69V-052

Safety Recall

G—09501 Interim Notice Revised

Subject: Bus Stepwell Heater Blower Motors

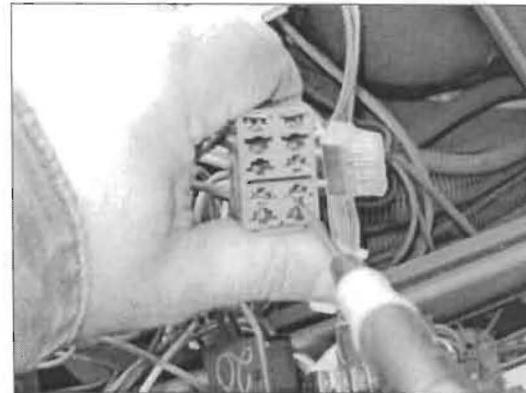
5. Depin the 12 gauge blue wire in cavity 3 of the harness connector using a spade tool to depress the terminal tab while simultaneously pulling the wire.

6. Wrap electrical tape around the terminal covering all the metal area well. Fold the depinned blue wire back on itself and tape. **This wire is energized when the motor is operated on high speed.**

- 1) Clarify your 3 available temporary options to prevent the listed defect from occurring.
- 2) Correct item 6 in the repair instructions should you elect to de-pin the switch. The de-pinned terminal will become energized with the blower switch in the high position. The terminal will need to be taped to prevent an electrical short.

- **Note: If you have already performed the third option below you must cover all the metallic area of the removed terminal with electrical tape so the terminal will not cause a grounding short.**
